Docket Number:	24-OPT-03
Project Title:	Soda Mountain Solar
TN #:	266864
Document Title:	Response to SDR BIO-1
Description:	Response to SDR BIO-1
Filer:	Hannah Arkin
Organization:	Resolution Environmental
Submitter Role:	Applicant Representative
Submission Date:	10/27/2025 2:29:00 PM
Docketed Date:	10/27/2025

Subject: Response to SDR BIO-1 Soda Mountain Solar Existing Offsite Proposed Well Location Assessment Project Site, San Bernardino County, California

Figure 3 Project Site and Existing Groundwater Well Location

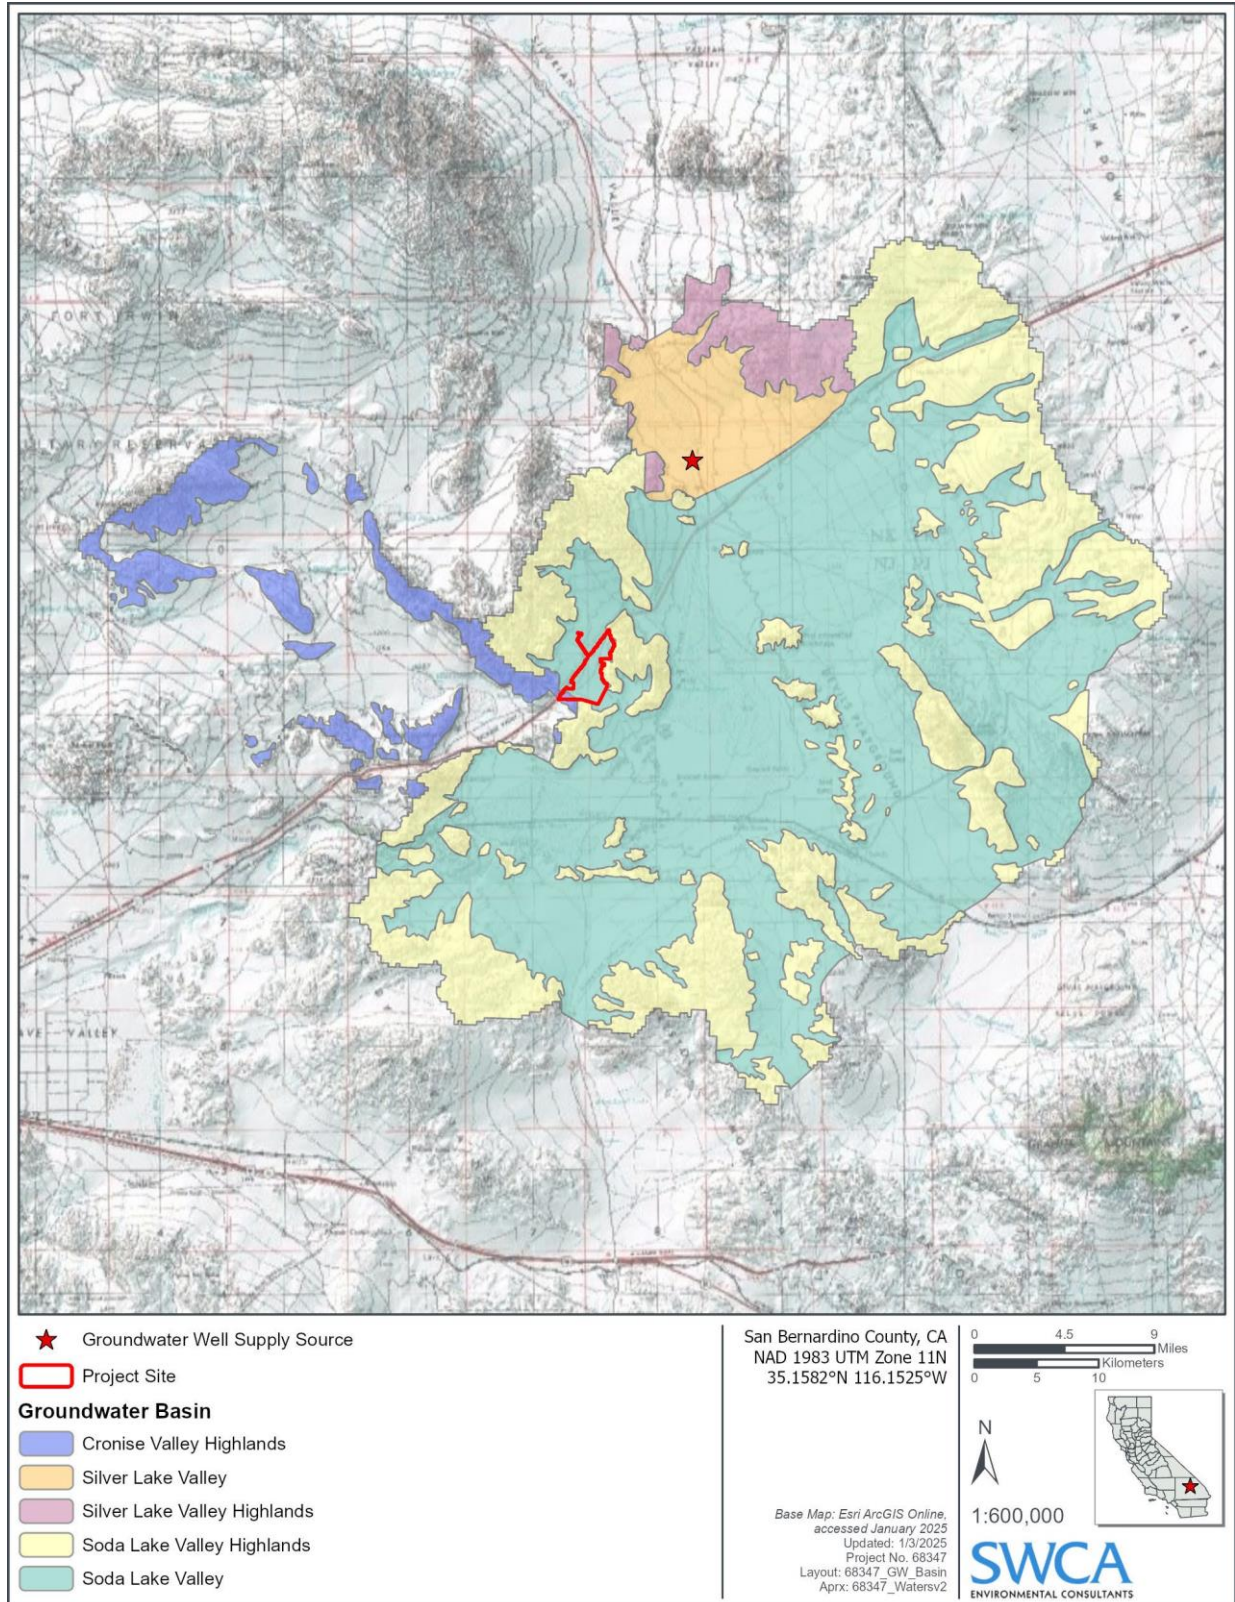
- a. Please provide a map showing the locations and land ownership of all proposed well locations.
- b. Please identify all access roads and or travel routes to gain access to these wells.
- c. Please provide the results of water quality testing for any existing wells.
- d. Please provide updated biological resource and jurisdictional waters data for any wells located outside of the existing project development footprint.

The existing offsite groundwater well is located within the Silver Lake Valley groundwater basin (see Figure 3). The existing well (Well Completion Report No. WCR2020-016662) was permitted by San Bernardino County Department of Public Health, Environmental Health Services, Safe Drinking Water Permit Program. The well was drilled in September 2020 to a completed depth of 400 feet below ground surface (bgs) with screening from 160 to 400 feet. Static water level was recorded at 30 feet. Well yield was recorded at 400 gallons per minute (DWR 2025).
